2021.11 Mass production inspection

Model Name: BFX-UA300

Document Version: ALT_STB_MP_CSMTINS_001

Critical issue

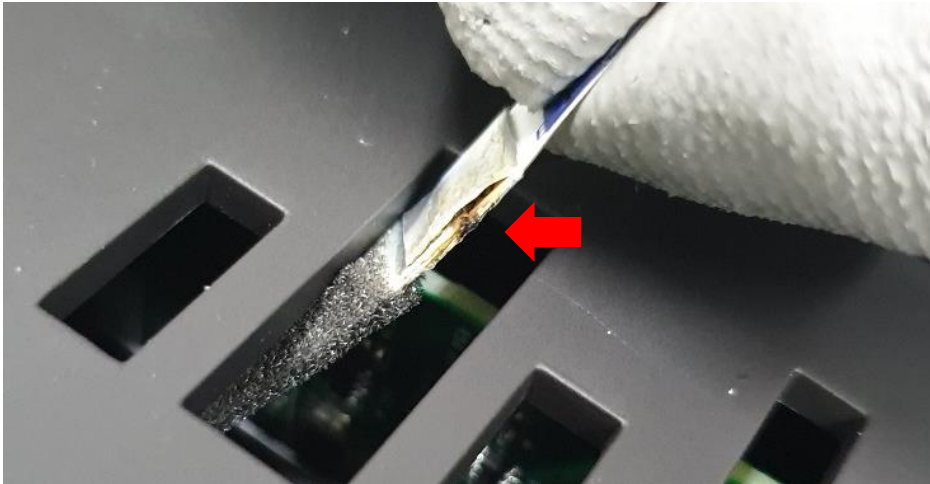
- Side LED not working
 - Issue grade : Critical
 - Symptom : R-Ch Side LED is not turn on
 - Defect unit Q'ty : 1pcs / 756pcs
 - Defect rate : 0.13%

- ALT initial review
 - Disassembly Front grill, the FFC was damaged.
 - Disassembly side LED ass'y, the FFC connector broken due to top cover rib
- ALT Action
 - Replace the Side LED PCBA, FFC cable
- Factory Action item
 - FXN should be submit 8D report
 - Check and verify rib cutting result at the factory

- Grill attachment NG

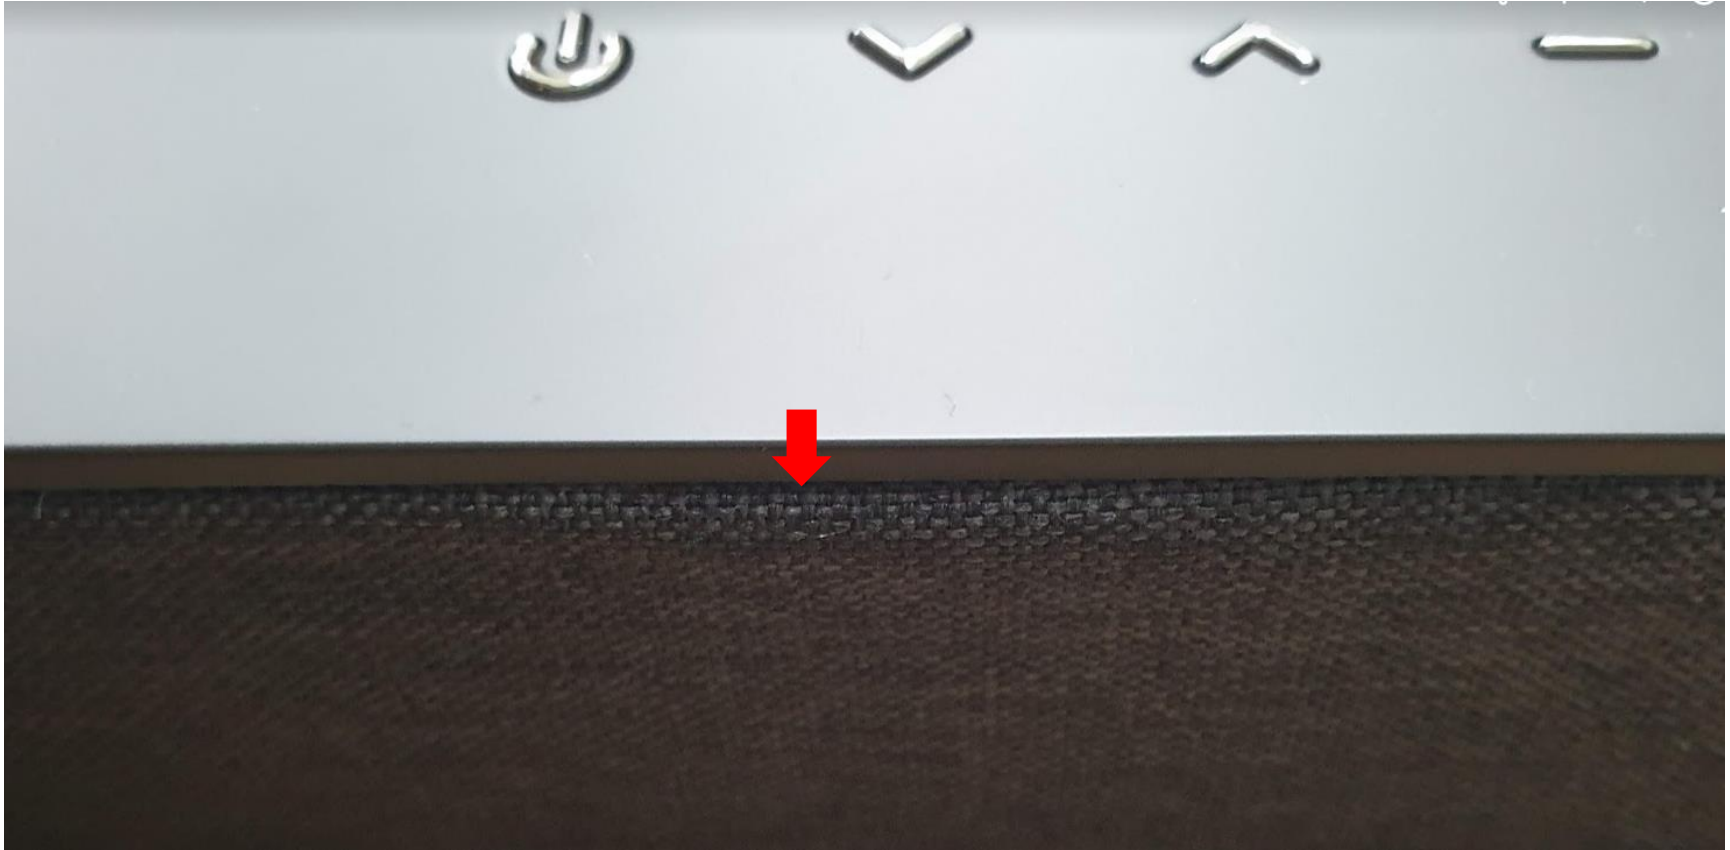
- Issue grade : Major
- Symptom
 - Attachment line NG
 - Defect unit Q'ty : 1pcs
 - Defect rate :

SKB SN		mac	Note
214965001	202109002041	a8:93:4a:fe:80:02	grill fabric adhesive apply NG

- ALT initial review
 - Grill assembly quality improvement in progress
 - grill fabric adhesive apply NG
 - If the fabric does not adhere completely, It can cause vibration noise.
 - ALT will send to Vender 8D report to factory
- Factory Action item
 - Please add the CTQ point – IQC, PQC, OBA
 - Please check the cosmetic point, and contact Vender(Inkel) direct.
 - Vender will provide replacement parts.
